March 26, 2015

Re: Comments of California Sportfishing Protection Alliance and American Whitewater on the *Draft Environmental Impact Report for the Water Quality Certification of Pacific Gas & Electric Company's Upper North Fork Feather Hydroelectric Project, Federal Energy Regulatory Commission Project No. 2105*

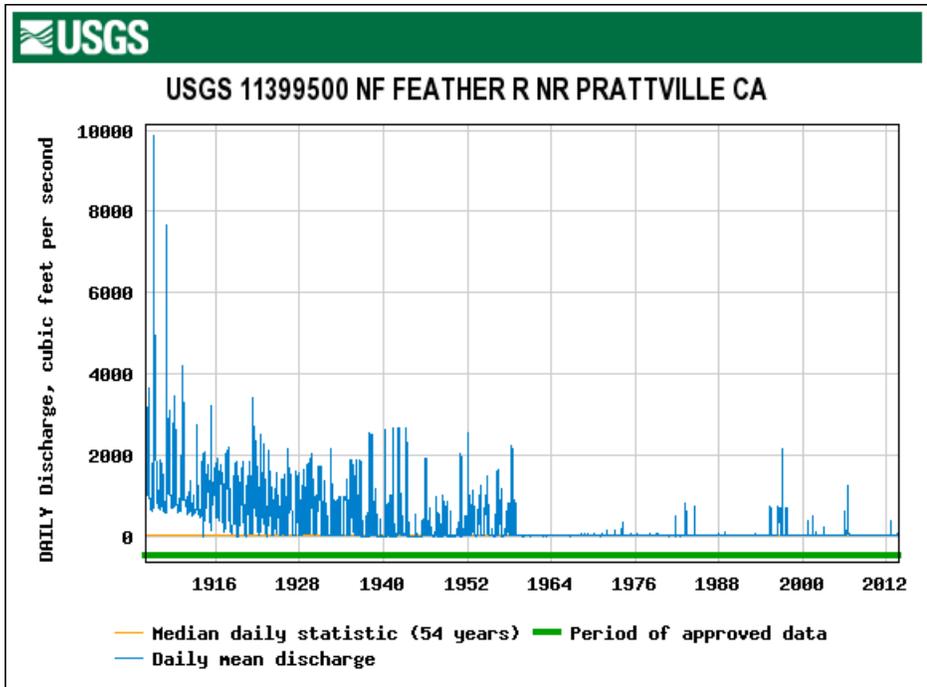
Summer water temperatures in the North Fork Feather River downstream of Caribou Powerhouse and Belden Reservoir cannot in any sense be construed as protective of cold water beneficial uses. Summer water temperatures on the Rock Creek and Cresta reaches are simply too warm. Since 2006, PG&E has provided summer water temperature data on a weekly basis to members of the Rock Creek – Cresta Ecological Resources Committee (ERC), a license implementation advisory body whose monthly meetings are faithfully attended by CSPA and AW and by a representative of State Board staff. This data is summarized in Annual Reports for the Rock Creek – Cresta Project that PG&E files each year, but the Annual Reports do not provide daily data. In all but the wettest years (e.g. 2011) mean daily water temperatures on the Rock Creek and Cresta reaches routinely exceed, for multiple consecutive weeks, the FERC-established benchmark of 20°C. The following table, compiled from weekly PG&E data provided to Rock Creek – Cresta ERC members, shows mean water temperatures from the summer of 2014.

In considering this data, one must take into account that the temperature monitoring stations are located in the stream channel near the upstream end of each reach. Temperatures increase as water moves downstream. In addition, the weekly mean of the maximum daily water temperature does not highlight the highest temperatures recorded in any given week. On the Rock Creek reach, the weekly highs (°C) for the time period shown in the chart above were 22.9, 22.7, 22.4, 23.4, 22.8, 22.6, 21.8, and 22.3. On the Cresta reach, the weekly highs (°C) for the time period shown in the chart above were 23.8, 23.8, 23.5, 24.0, 23.7, 23.4, 22.8, and 22.9.

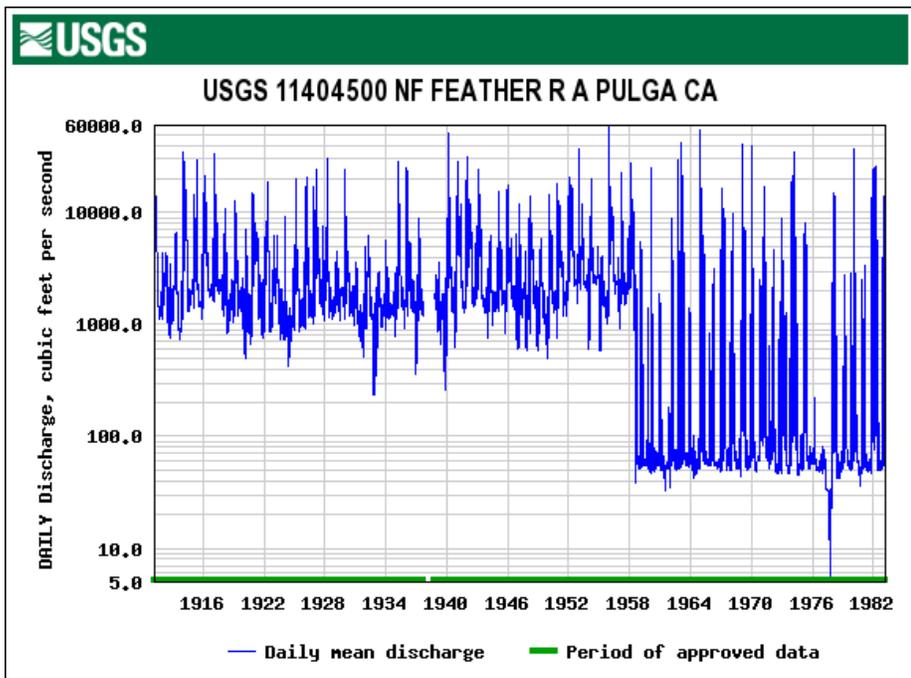
The record for the USGS gauge on the North Fork Feather River near Prattville, located just below Canyon Dam, clearly shows the impact of hydroelectric development on the North Fork Feather River. This record includes the period from 1906 to 1914, before the first incarnation of Canyon Dam was constructed. The record shows that pre-project flows rarely dropped below 1000 CFS. After the dam’s construction, flow still remained relatively high until the middle part of the last century. After the final raise of Canyon Dam was completed in 1962, over 95% of the flows were being diverted from the upper reaches of the North Fork Feather River.
